PRODUCT CHANGE NOTICE

PCN#23-043**NOTIFICATION DATE: July 26, 2023****MODELS AFFECTED****ZN4PD1-63LW-S+****EXTENT OF CHANGE:**

FROM:**TO:****EFFECT OF CHANGE:**

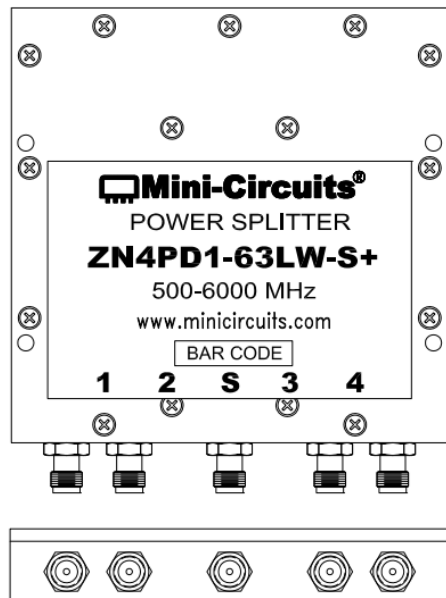
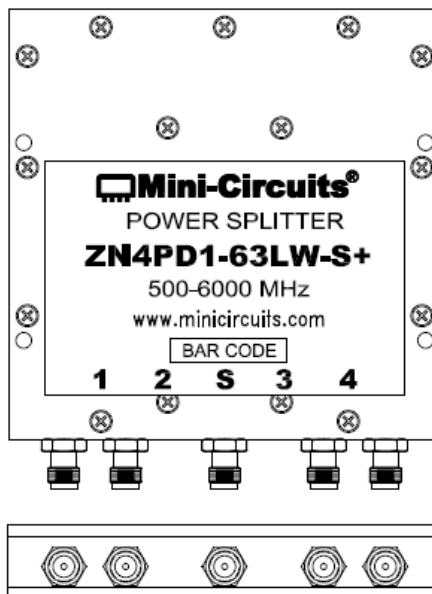
Modification of mechanical assembly by adding bottom cover and screws to case

Change to FORM (Appearance)

Improved assembly and spec achievement
